APPLICATION NO.	FILING DATE	FIRST NAMED INVENTOR	ATTORNEY DOCKET NO.	CONFIRMATION NO.
10/798,814	03/10/2004	Sung-Yong Kang	21C-0117	7126
23413	7590	11/21/2006		
CANTOR COLBURN, LLP 55 GRIFFIN ROAD SOUTH BLOOMFIELD, CT 06002				EXAMINER CHEN, WEN YING PATTY
			ART UNIT 2871	PAPER NUMBER

Office Action Summary	Application No.	Applicant(s)
	10/798,814	KANG ET AL.
	Examiner W. Patty Chen	Art Unit 2871

DETAILED ACTION

FIG. 4A

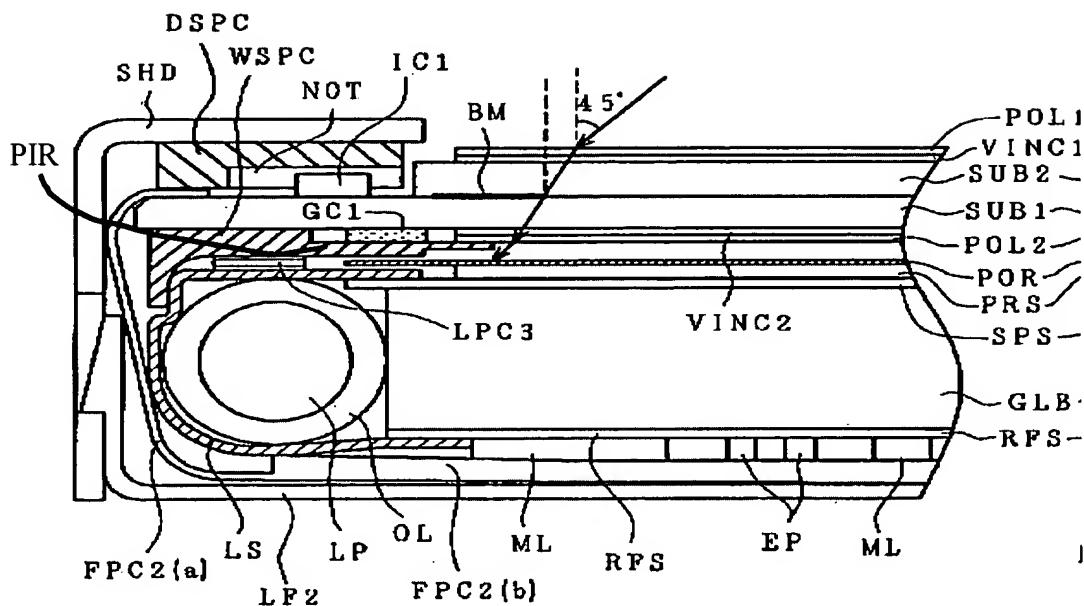
As to claim 10: Yoshii et al. further disclose in Figure 4A that the particle interceptor corresponds to a particle intercepting protrusion (element GC1) formed on the first face of the first supporting member frame portion (base portion of element WSPC) in at least one row, and the particle intercepting protrusion includes a material having flowability (Column 10, lines 62-63, wherein the protrusions are made of rubber).

As to claim 12: Yoshii et al. further disclose in Figure 4A that the particle interceptor includes particle intercepting protrusions (element GC1) formed on the first face, and at least one particle intercepting recess (element PIR as shown in figure below) formed on the particle intercepting protrusions.
